**Dam Safety Assessment of CCW
Impoundments**

**Reid/Green/HMP&L Station II
Report**

**Lockheed Martin
Contractor for the USEPA**

October 2009

FIGURE 3

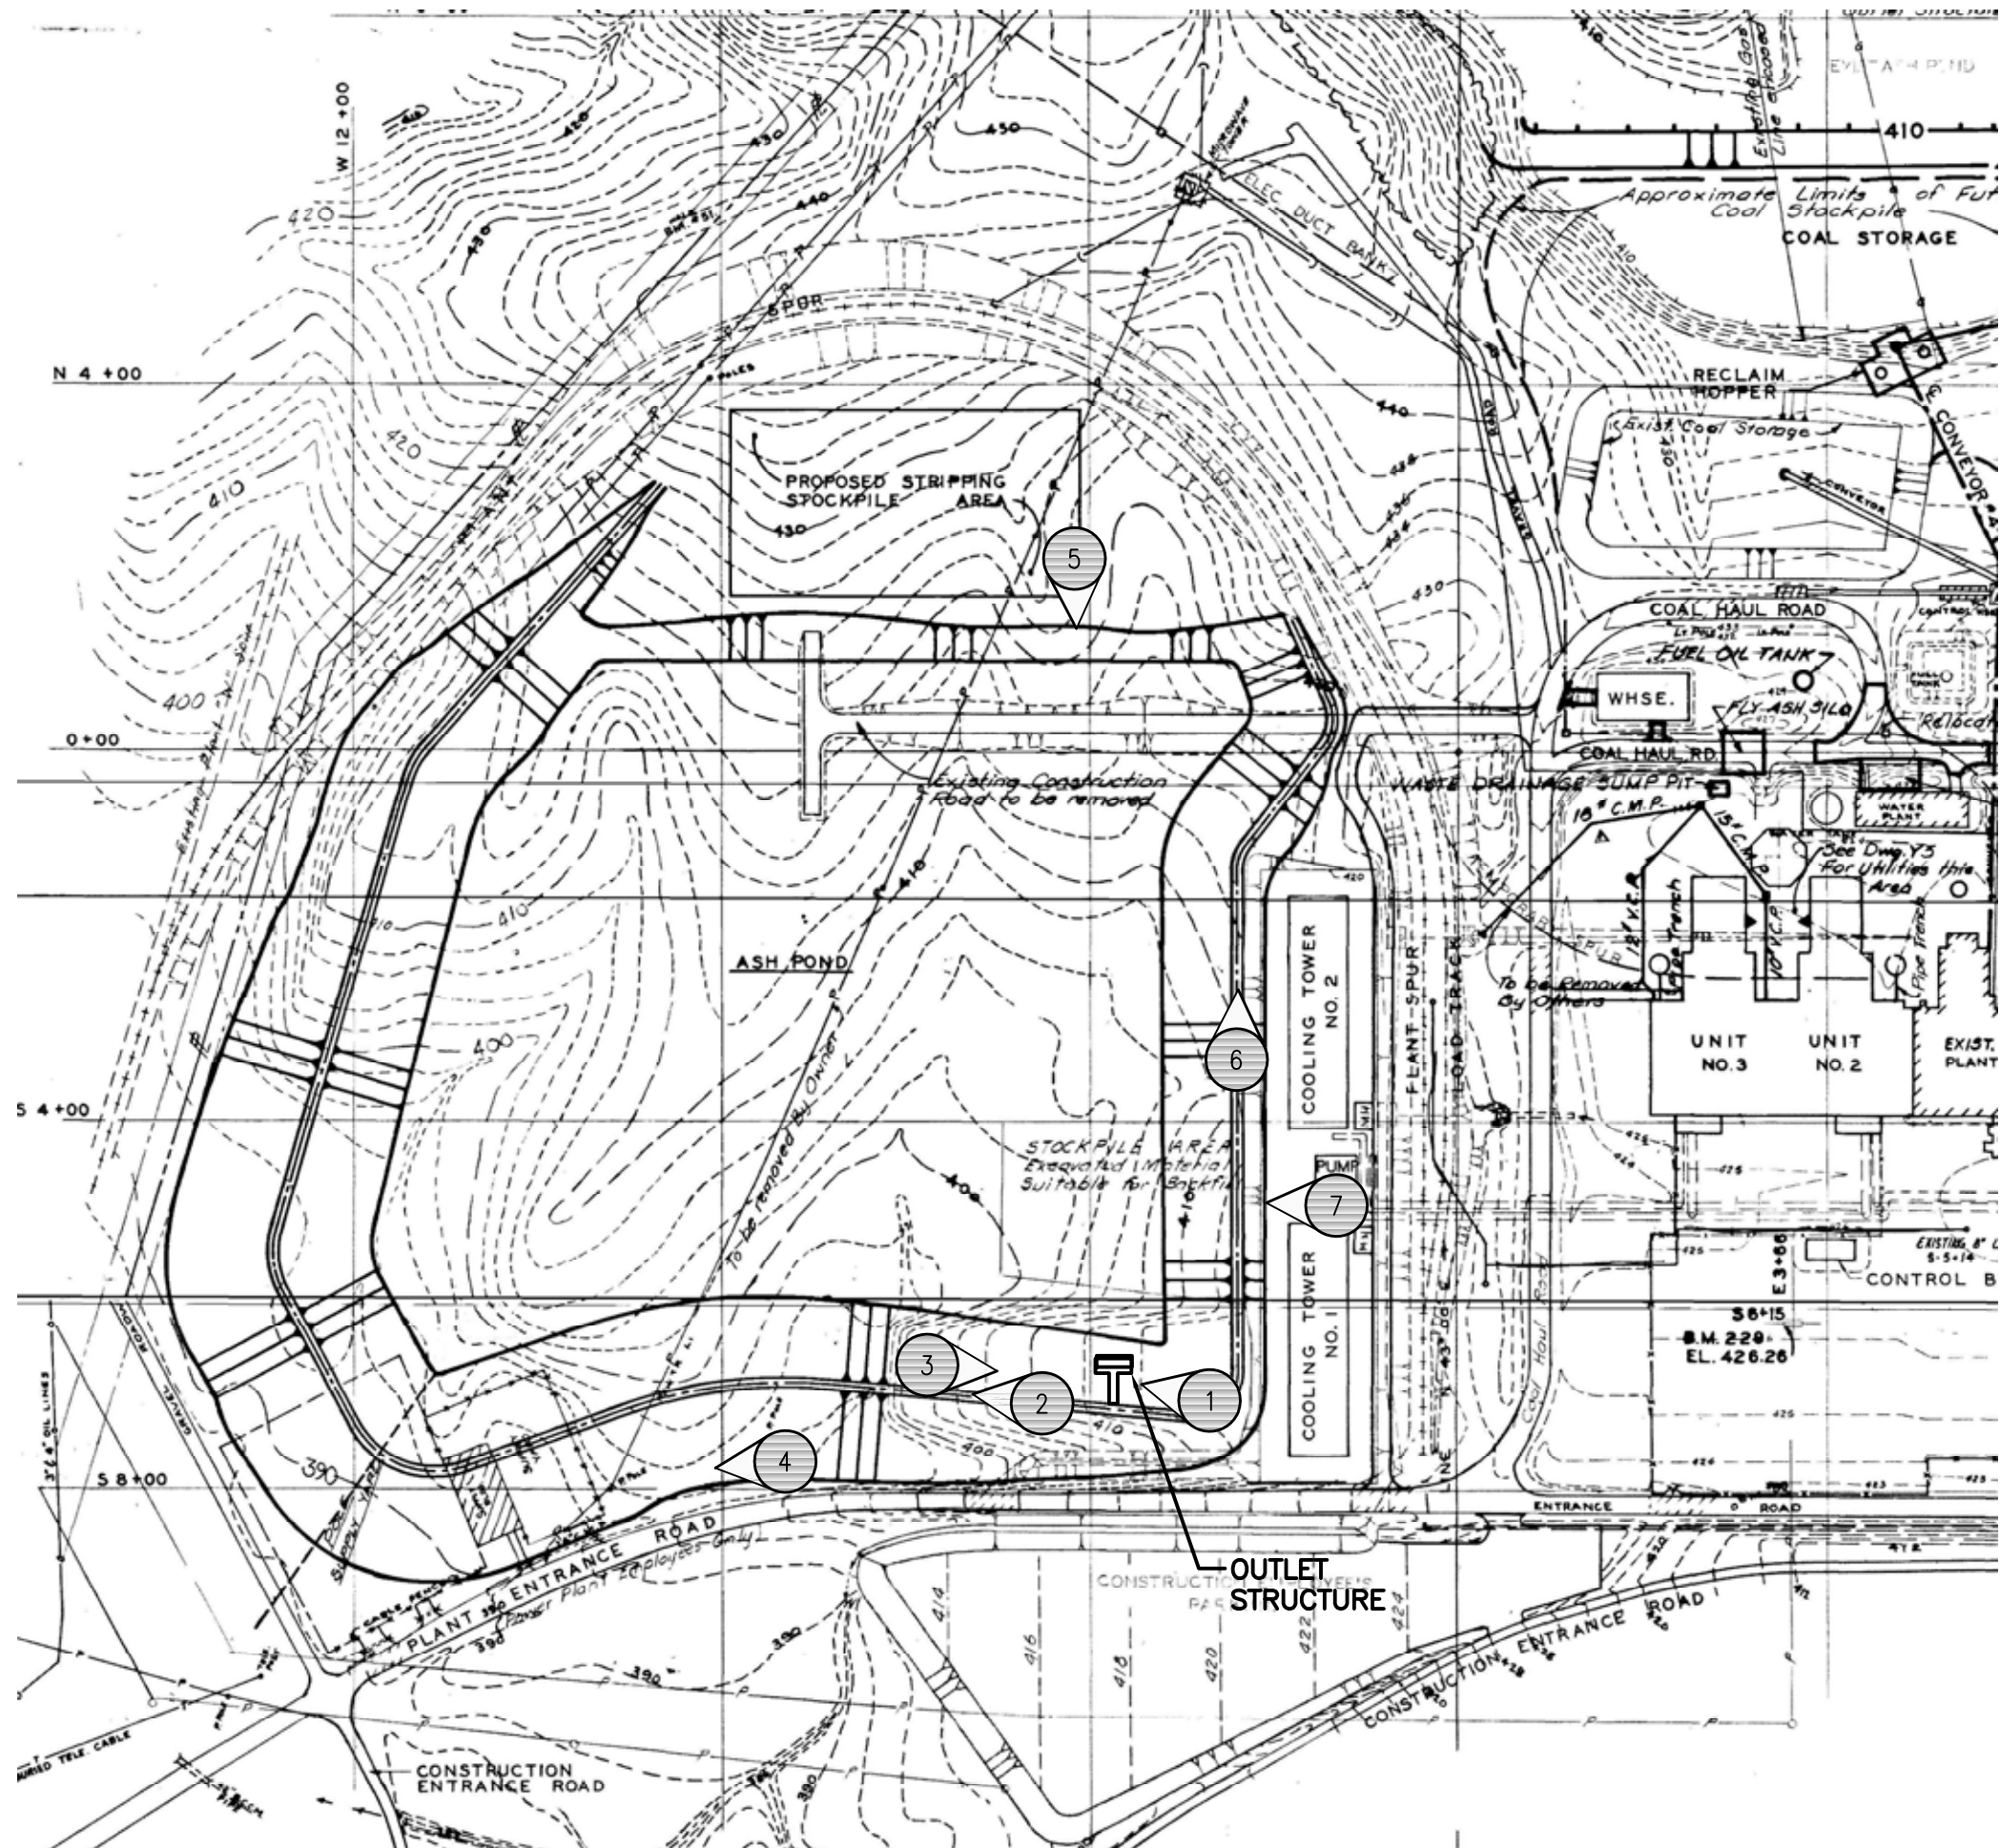
Photos of relevant features and conditions observed during the inspection were taken by O'Brien & Gere and are provided in Appendix B and C for the Reid/HMPL Ash Pond and the Green Ash Pond, respectively. Site Plans of the Reid/HMPL Ash Pond and the Green Ash Pond are presented as Figure 3 and 4, respectively, which provide photograph locations and directions.

- Sluiced CCW by-product discharge enters the pond near the northeast corner and is routed to the south end of the pond through a shallow ditch that has been excavated into the accumulated bottom ash deposits (Appendix B –Photo 5).

- Vegetative cover on the eastern outboard slope is poor, and is experiencing erosion problems, as a result. We also understand that portions of the eastern outboard slope along the cooling

towers were excavated to a relatively steep grade to provide crane access between the cooling tower and the toe of slope (Appendix B – Photo 7) .

- A mature willow tree is growing on the eastern crest and inboard slope.
- The outlet structure appeared to be in good condition and functioning normally (Appendix B – Photo 1) .

- Crest – fill ruts on crest and re-establish vegetative cover. Remove willow tree from crest of eastern dike.
- Inboard slopes – repair eroded inboard slopes. Repairs should be completed in accordance with an engineered design. Inspect and maintain erosion that may develop on freeboard section of all inboard slopes on a regular basis. Keep vegetation under control to allow for visual inspection of the exposed portion of the slope above the waterline.

- Outboard slopes – restore the eastern slope to its design inclination and re-vegetate. The slope restoration should be performed in accordance with an engineered design with reference to the original design. Remove wooden poles embedded in slope and backfill with compacted fill consistent with the original design.

- Outboard toe – regrade the swale along the toe to improve drainage. The swale may need to be lined with alternate materials, such as crushed stone or concrete to alleviate the soft soil condition. Consider installing a V-notch weir to monitor seepage flow rate. Remove wooden poles and fill with compacted material consistent with the dike design.
